Issue Date	Rev	Description	Drawn	Checked
15/09/2016	A	ISSUED FOR DEVELOPMENT APPLICATION	DVI	LT
07/02/2017	B	DEFERRED COMMENCEMENT - DA AMENDMENTS	DVI	LT
13/03/2017	C	SECTION 96 - LIGHTWELL	DVI	LT
24/05/2019	D	SECTION 96	DVI	LT
APRIL 2020	F	REVISED SECTION 96	DVI	LT

PROJECT	
GARLING HOUSE PROPOSED NEW RESIDENCE 24 LANCASTER CRESCENT, COLLAROY NSW LOT 3 DP.11899	
FOR MR & MRS GARLING

DRAWING TITLE	
PLANS SITE PLAN	
SCALE 1:200, 1:100 @ A2	DRAWN BY LT/DVI
PROJECT NO. 1612	PLOT DATE 9/04/2020
	REVISION
	DA-01 F

POOL PRIVACY SCREEN SECTION 1:100

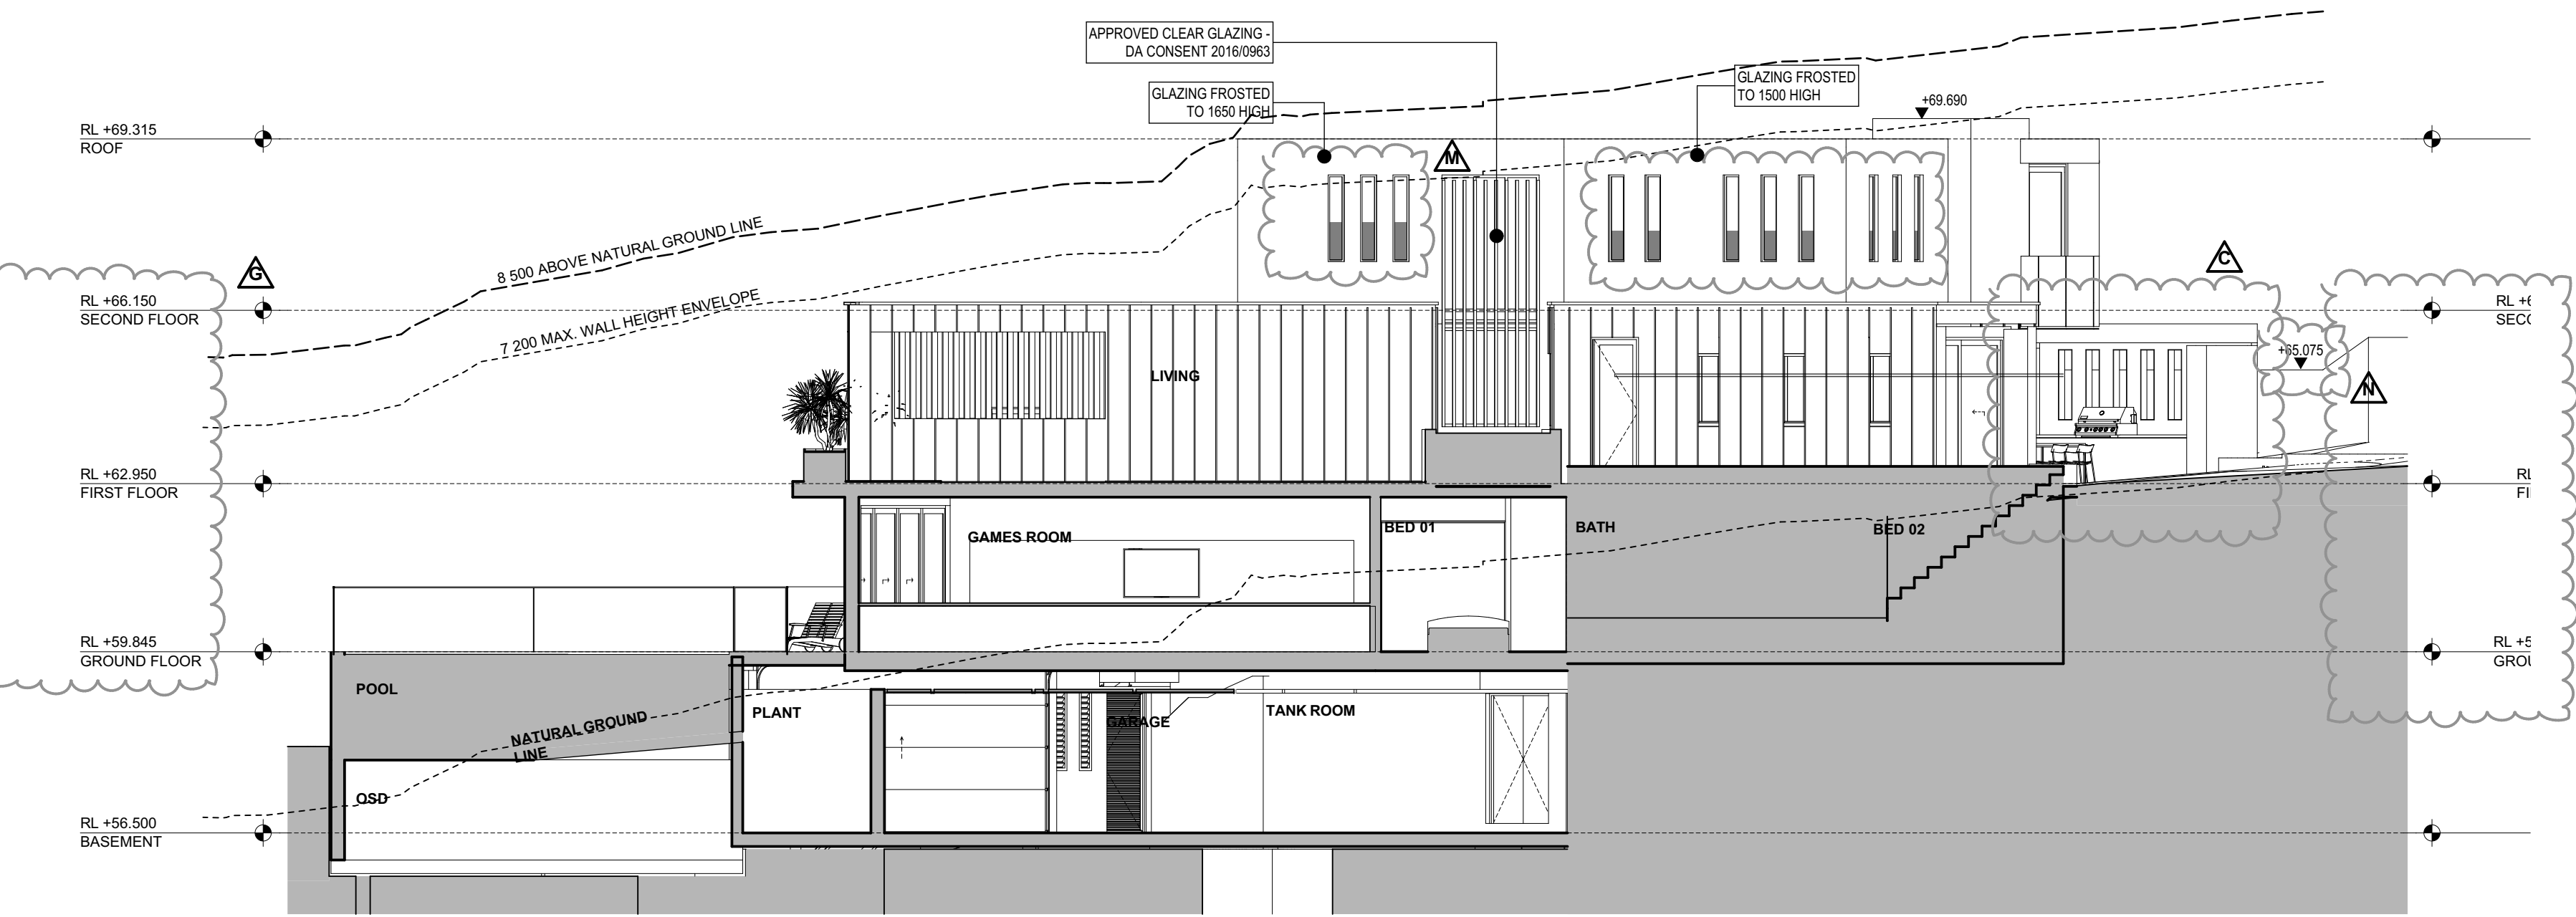
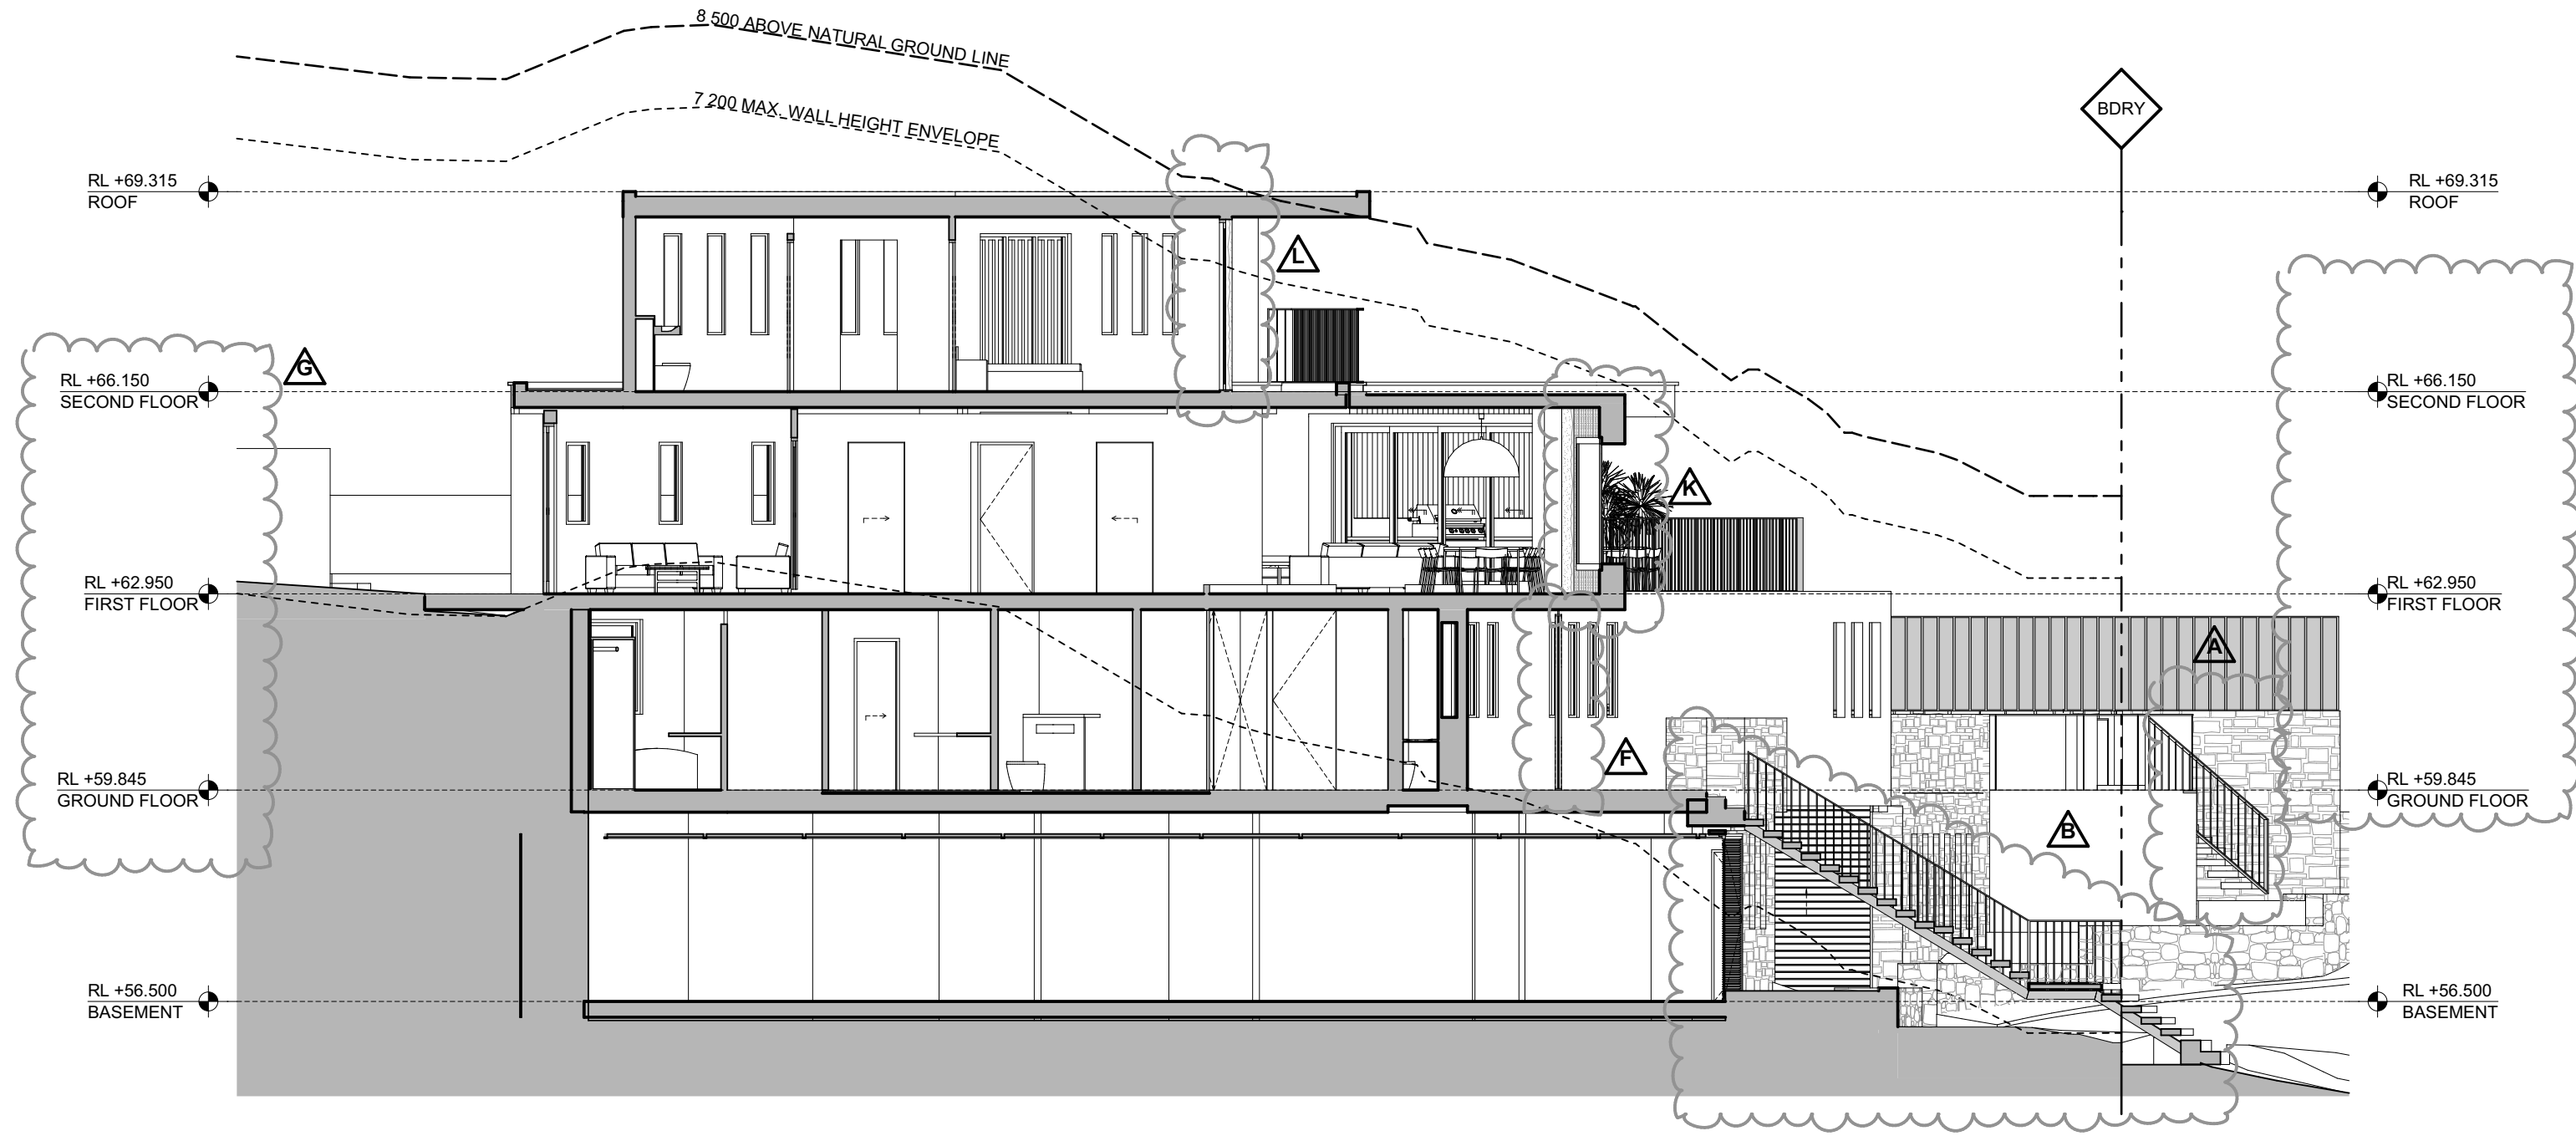
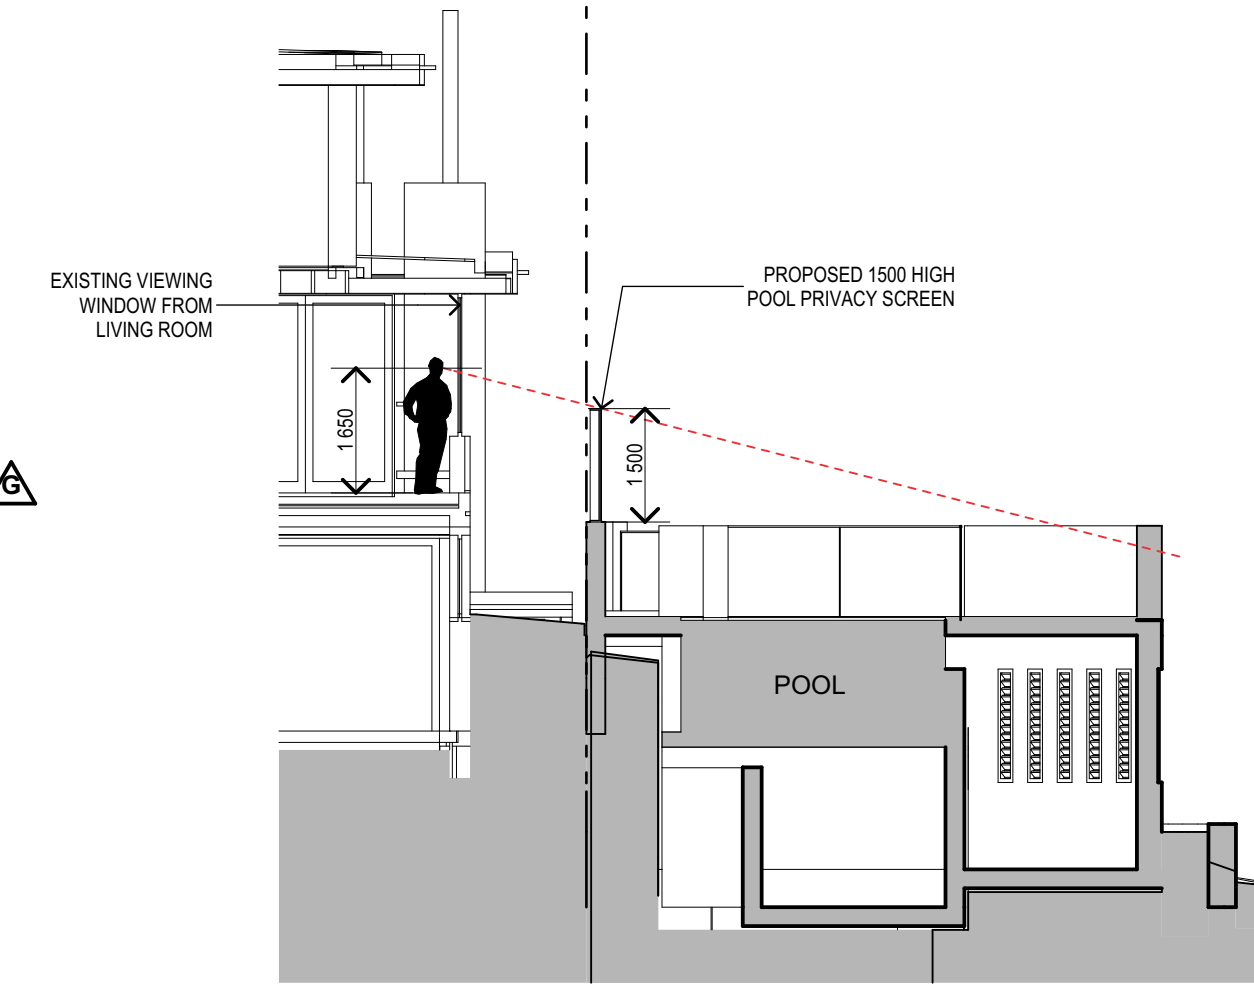
- SCHEDULE OF S96 AMENDMENTS**
SECTIONS D + E
- ACCESS GATE AND STAIR FROM POOL ENCLOSURE TO ALLOW ACCESS TO STREET FRONT LANDSCAPE AREA
 - STREET FRONT ACCESS STAIR AMENDED TO SUIT ROCK FACE AND ENTRY STRUCTURE REMOVED
 - REAR FIRST FLOOR DECK PEGOLA REMOVED AND NEW ROOF OVER DECK
 - FRONT ENTRY GATE + VESTIBULE AND POND ADDED
 - FLOOR LEVELS AMENDED
NOTE NO IMPACT ON HEIGHT
ROOF LEVEL NOT CHANGED
 - BOUNDARY POOL PRIVACY SCREEN ADDED TO TOP OF WALL - 15000 HIGH REFER SECTION ON DA-11
 - ENTRY PERGOLA STRUCTURE REMOVED + FRAMED VIEWING WINDOW AND WINDOW SLOTS ADDED/AMENDED
 - MASTER BEDROOM GLAZING EXTENT TO SOUTH ELEVATION AMENDED
 - MASTER BEDROOM DAY BED - OBSCURE GLASS TO 1650 HIGH WINDOW SLOTS ADDED EAST ELEVATION
 - BOUNDARY FENCE LEVELS ADDED
